ATTACHMENT C

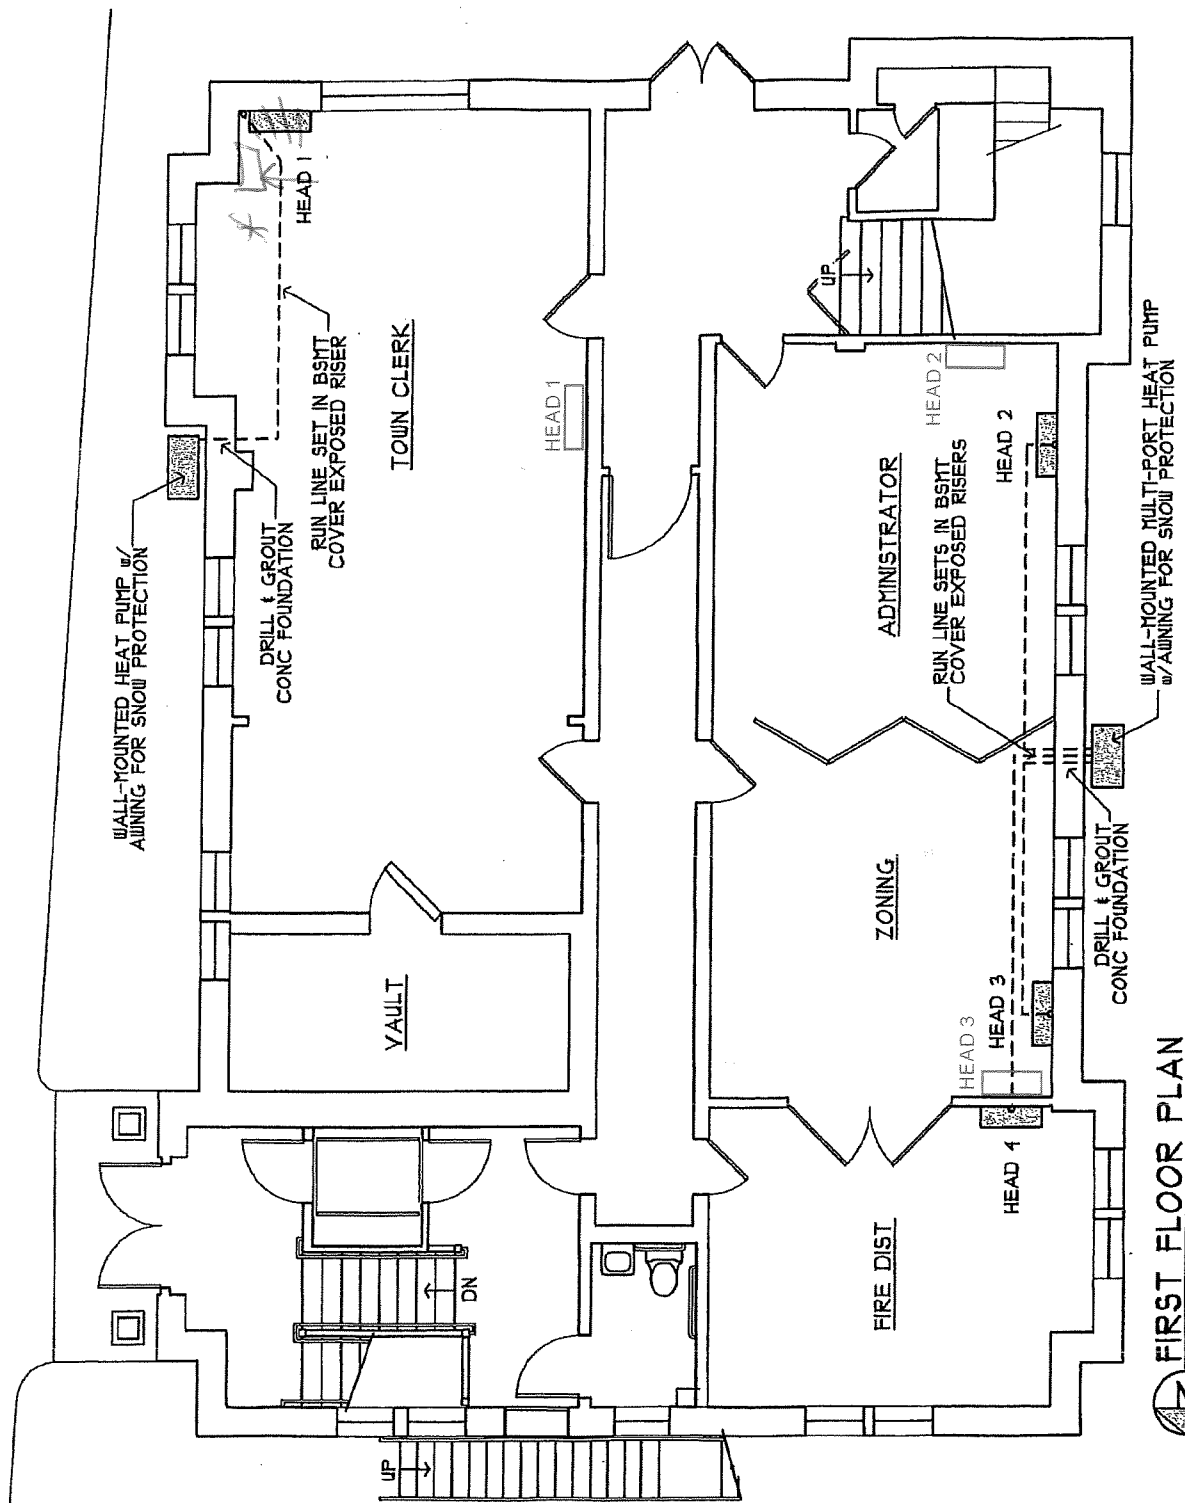
NOTE: Based on our conversation yesterday, these locations seem to be better because they will no interfere with the hot water baseboard heating. Also, placing Head 3 and 4 back-to-back could allow a single chaseway with both linesets to service both heads.
